Sliding Roof Binds When Opening or Closing

Service Category Vehicle Exterior

Section Sliding Roof/Convertible

Figure 1.

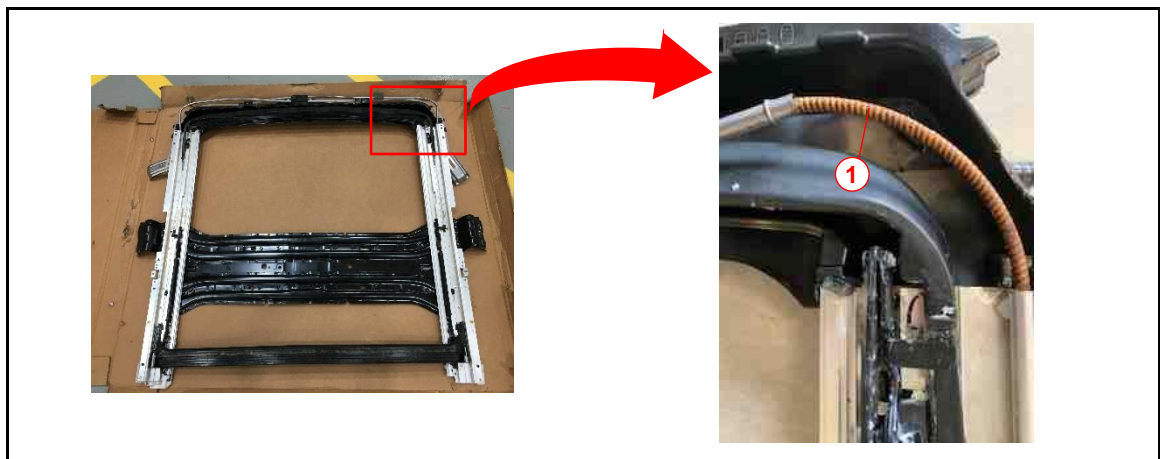
Some 2018 – 2020 model year Sequoia and Tundra vehicles equipped with a sliding sunroof or moonroof may exhibit a binding, seizing, or sticking condition when attempting to open or close. In some cases, a clicking noise is present when the sliding sunroof or moonroof is stuck open or closed. This condition may be caused by rusted or seized sliding roof cables. Follow the Repair Procedure in this bulletin to address this condition.

1	Corroded Sliding Roof Cable
----------	------------------------------------

2. Replace BOTH the sliding roof housing sub-assembly AND the sliding roof cables.
 - A. Remove the sliding roof housing sub-assembly AND sliding roof cables.
 - 2018 – 2020 Sequoia:
Vehicle Exterior – Sliding Roof/Convertible – [“Sliding Roof / Convertible: Sliding Roof Housing: Disassembly”](#)
 - 2018 – 2020 Tundra:
Vehicle Exterior – Sliding Roof/Convertible – [“Sliding Roof: Sliding Roof Housing \(for Crew Max\): Disassembly”](#)
 - B. Install the NEW sliding roof drive cable sub-assembly AND the NEW sliding roof cables.
 - 2018 – 2020 Sequoia:
Vehicle Exterior – Sliding Roof/Convertible – [“Sliding Roof / Convertible: Sliding Roof Housing: Reassembly”](#)
 - 2018 – 2020 Tundra:
Vehicle Exterior – Sliding Roof/Convertible – [“Sliding Roof: Sliding Roof Housing \(for Crew Max\): Reassembly”](#)
